January 3, 2022

Thank you for your letter in response to our application for preliminary site plan review for the property at 148 Myrtle St in Melrose. Our response below contains responses to the 9 questions outlined in your response dated December 22, 2021.

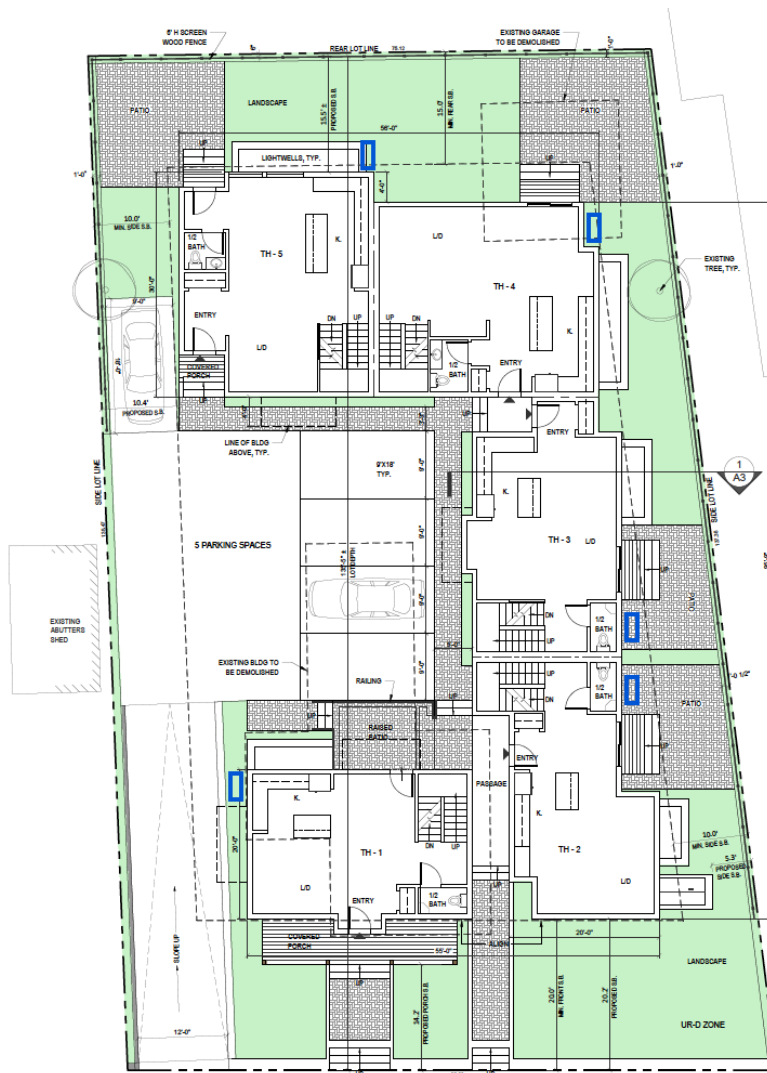
4. Where would the snow be stored for small and large events? It does not seem possible that a bobcat could access the backyard.

5. Where will the units for the heat pumps be located?

Snow management for storms will be addressed by plowing smaller snow event storms to the back of parking spaces resulting in smaller snow banks on property.

Larger snow events will be stored at the back left of the property beyond the parking space for unit # 5. That unit owner will be required to move their car during larger snow events for snow removal. A bobcat can easily access this portion of the property which carries in width from 10 - 12.5'

In order to better accommodate storage for large snow events, we plan to relocate the trash and recycling bin storage to the side of Unit 1 along the drive aisle. This change will be indicated in a plan update which we will provide before the meeting.

The heat pumps will be located directly abutting each unit. Plans will be updated shortly to reflect this. The diagram below indicates heat pump locations with blue squares.
